RFI	AE Response	VA Response
1.	Are the mechanical, plumbing and electrical drawings date 6/23/16 that were included in the bid set of documents the correct drawings?	Drawings dated 6/23/16 are correct. Revised drawings, with the correct date, have been provided to the VA for distribution. No changes were made to the drawings other than the date.

ERIE WATER TANK

6 PIPE BOLLARD
NOT TO SCALE

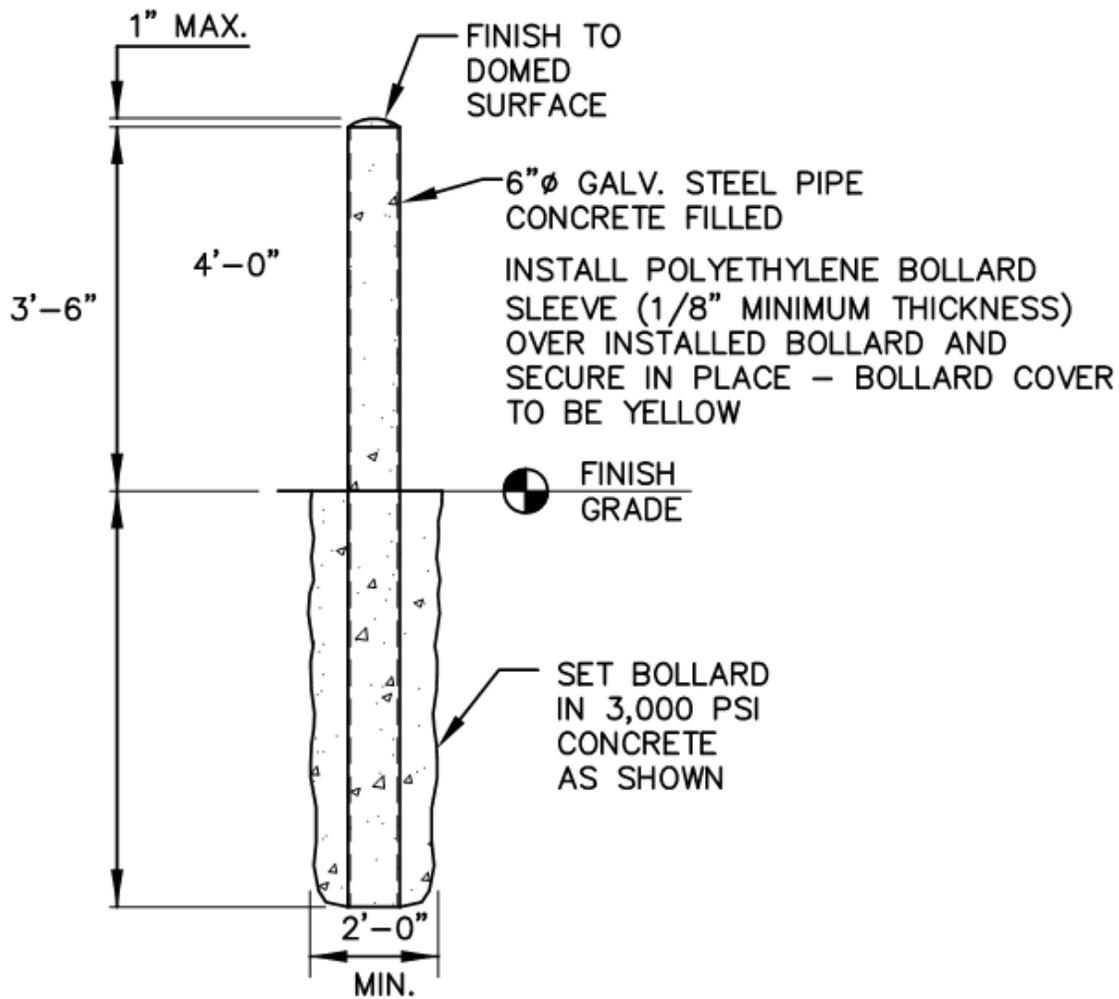
engineer. We can't bid the tank foundation without the design.	stamped by a licensed engineer in the state of Pennsylvania.	
6.	<p>Drawing A101 Keynotes:</p> <p>#20 states: Emergency generator, provide thickened slab. How much thickened should the slab be?</p> <p>#21 steel encased concrete bollard. See 6/C501 for detail. This detail is a concrete curb section. Is there a detail that we should reference?</p>	<p>#20 – The emergency generator may be removed from project. No thickened slab will be necessary.</p> <p>#21 – See attached drawing for detail of concrete bollard.</p>
